Work Order ID 160222

Item Name: AS350/AS355 Quick Release Heli-Utility-Basket™, Short, Heavy Duty Lid (Matte Black) Stop *NS2*

DART SERVICE INSTRUCTION

TO AMEND INSTALLATION INSTRUCTIONS D350-607-3 Rev.D,
INSTALLATION INSTRUCTIONS D350-607-4 Rev. C AND
INSTRUCTIONS FOR CONTINUED AIRWORTHINESS ICA-D350-607 REV. 6
REF TCCA STC: SH94-14
REF FAA STC: SR00213NY
REF EASA STC: EASA.10016996
REF BRAZILIAN STC: 2007S03-03/-04/-05/-06

FIGURE 1: INSTALLATION OF D4775-041 FWD STRUT

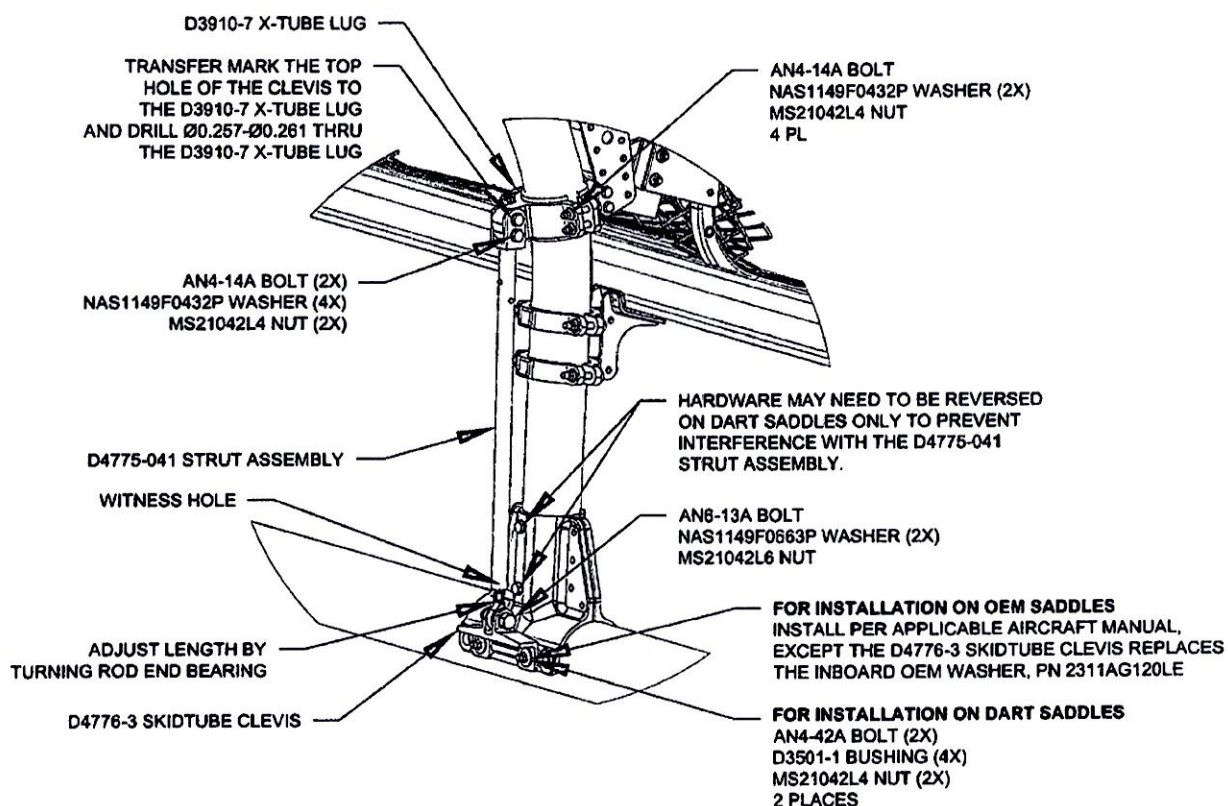
- 3.1 Substitute the Forward Lower D3910-5 X-Tube Lug with the D3910-7 X-Tube Lug as shown in Figure 1.
- 3.2 Install the forward D4775-041 Strut Assembly. Transfer mark from the upper hole on the clevis of the D4775-041 Strut Assembly to the D3910-7 X-tube Lug and drill thru the lug $\varnothing 0.257\text{-}\varnothing 0.261$ as shown in Figure 1. Touch up chemical conversion coating per MIL-DTL-5541. Check the witness holes located at the bottom end of the D4775-041 Strut Assemblies to ensure that the thread from the rod end extends past the witness hole.
Torque MS21042L4/-4 nuts to 50-70 in-lbs (5.7-7.9 N-m). Torque MS21042L6/-6 nuts to 160-190 in-lbs (18.1-21.5 N-m).
- 3.3 Complete the installation in accordance with Installation Instructions D350-607-3 Rev. D or D350-607-4 Rev. C.
